SYM	DESCRIPTION	DATE	APPR
1	MEMORANDUM NO.3	4-15-15	----

DEPARTMENT OF THE NAVY
NAVAL FACILITIES ENGINEERING COMMAND
IPT SOUTH ATLANTIC
AUTEC SITE 1

PIER 1902 REPAIRS

GENERAL NOTES AND ABBREVIATIONS

6 TYPICAL RUBBER FENDER DETAIL (OPTION)
Scale: 3/8" = 1'-0"

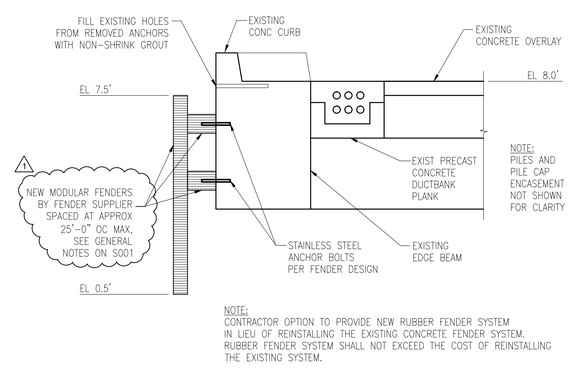
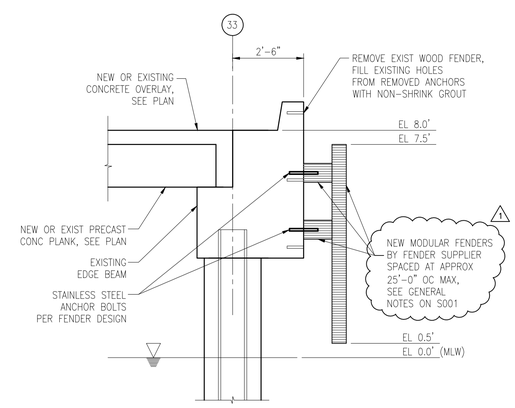
1) PROVIDE MODULAR FENDER SYSTEM AS A REPLACEMENT OPTION FOR THE EXISTING CONCRETE FENDER IF EXISTING FENDER NEEDS TO BE REMOVED FOR CONSTRUCTION ACCESSIBILITY (SEE EXISTING CONCRETE FENDER REMOVAL NOTES ON THIS SHEET). 1

2) THE MODULAR FENDER SYSTEM SHALL BE DESIGNED BY A LICENSED ENGINEER EMPLOYED BY THE FENDER SUPPLIER.
3) CONSTRUCTION SHALL BE MADE OF NON-CORROSIVE MATERIALS INTENDED FOR SALT WATER MARINE ENVIRONMENTS. 1

4) MODULAR FENDER SYSTEM SHALL BE DESIGNED FOR THE VESSEL INFORMATION PROVIDED IN THE DESIGN LOAD SECTION ON THIS SHEET. 1
5) MODULAR FENDER SYSTEM SHALL HAVE MATERIAL PROPERTIES AS FOLLOWS:
   MINIMUM TENSILE STRENGTH---------- 2,300 PSI (PER ASTM D638)
   MINIMUM BOND STRENGTH (RUBBER TO STEEL)------ 1,000 PSI (PER ASTM D429)

6) MODULAR FENDERS SHALL HAVE A LOW FRICTION FACE SHIELD COMPOSED OF ULTRA HIGH MOLECULAR WEIGHT POLYETHYLENE (UHMW-PE) MEETING THE REQUIREMENTS OF ASTM D6712. 1

NOTE:
CONTRACTOR OPTION TO PROVIDE NEW RUBBER FENDER SYSTEM IN LIEU OF REINSTALLING THE EXISTING CONCRETE FENDER SYSTEM. RUBBER FENDER SYSTEM SHALL NOT EXCEED THE COST OF REINSTALLING THE EXISTING SYSTEM.
